APPLICATION NO.	FILING DATE	FIRST NAMED INVENTOR	ATTORNEY DOCKET NO.	CONFIRMATION NO.
10/076,660	02/15/2002	Robert Lance Cook	25791.76	9727
62519 HAYNES AND	7590 03/14/200 D BOONE, LLP	EXAMINER		
901 MAIN STR		LEE, CLOUD K		
SUITE 3100 DALLAS, TX 7	75202-3789		ART UNIT	PAPER NUMBER
,			3753	
			MAIL DATE	DELIVERY MODE
			03/14/2008	PAPER

Application No.	Applicant(s)				
	10/076,660	COOK ET AL.				
Office Action Summary	Examiner	Art Unit				
	CLOUD K. LEE	3753				
The MAILING DATE of this communication app	ears on the cover sheet with the c	orrespondence address				
Period for Reply						
A SHORTENED STATUTORY PERIOD FOR REPLY WHICHEVER IS LONGER, FROM THE MAILING DA - Extensions of time may be available under the provisions of 37 CFR 1.13 after SIX (6) MONTHS from the mailing date of this communication. - If NO period for reply is specified above, the maximum statutory period w - Failure to reply within the set or extended period for reply will, by statute, Any reply received by the Office later than three months after the mailing earned patent term adjustment. See 37 CFR 1.704(b).	ATE OF THIS COMMUNICATION 36(a). In no event, however, may a reply be tim vill apply and will expire

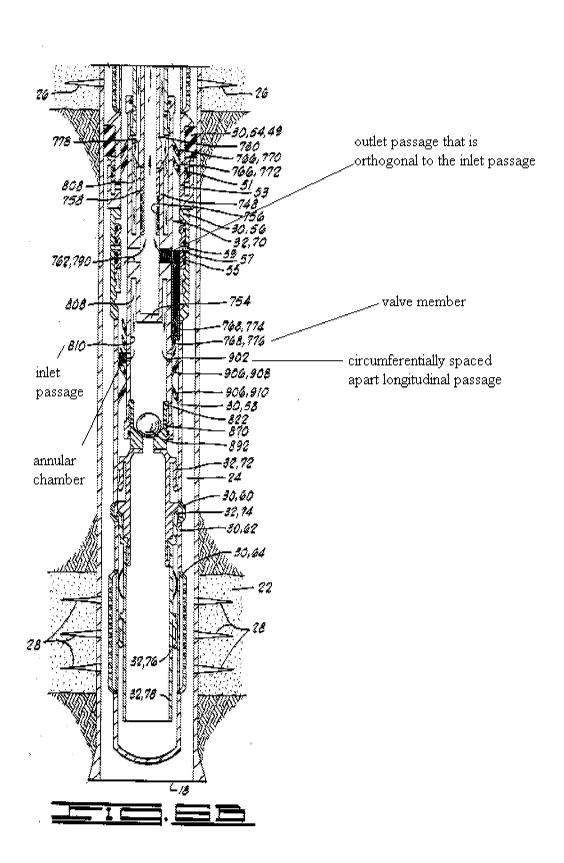
Szarka discloses a method of controlling the flow of fluidic materials comprising an injecting fluidic materials into the inlet passage (810), blocking the inlet passage (892) with a ball plug (892), conveying the injected fluidic materials radially out of the inlet passage (see figure 6B) into a plurality of circumferentially spaced apart longitudinal passages (902) defined in the tubular housing and into an annular chamber defined in the tubular housing that surrounds the inlet passage (annular space between 902 and 768), opening the outlet passage to permit

fluidic materials within the inlet passage and the annular chamber to be conveyed out of the housing (see figure 6B element 768, 785 and 776, also see Col 16 lines 56-68, and the ball valve 348), wherein the method further comprising preventing debris from entering the annular chamber (by using screen means 64), wherein the method further comprising detecting the operating pressure of the injected fluidic materials, and if the detected operating pressure of the injected fluidic materials exceeds a predetermined amount (see Col 16 lines 56-68, when the pressure in the annular chamber exceeds the biasing force or predetermined amount, the check valve 768, 776 will open and allow injected fluidic material to flow to the outlet passage 762 and 790) then opening the outlet passages (760 and 790), wherein the operating pressure is remotely detected by the check valve (768 and 776). Szarka further discloses the method to include an operating procedure that when if the detected operating pressure of the injected fluidic materials exceeds about 500 to 3000 psi (see Col 19 lines 19-23), then displacing valve members (see Col 19 lines 36-43) positioned within corresponding longitudinal valve chambers defined in the tubular housing, wherein the method further includes controlling the rate at which the fluidic materials are conveyed out of the tubular housing through the outlet passages using variable orifices when the valve members (768, 774 and 768) are displaced in a variable position and created a variable orifices, wherein the outlet passages (between 762 or 792 and the annular chamber, please see figure below) are orthogonal to the inlet passage (see 902). Please also see figure in this Office Action.

In response to applicant's argument that Szarka's reference fails to show the outlet passages are orthogonal to the inlet passage, please refer to the figure above. Szarka's reference shows the outlet passages (790 and 762 with filled portion as shown in figure) are orthogonal to the inlet passage (810)
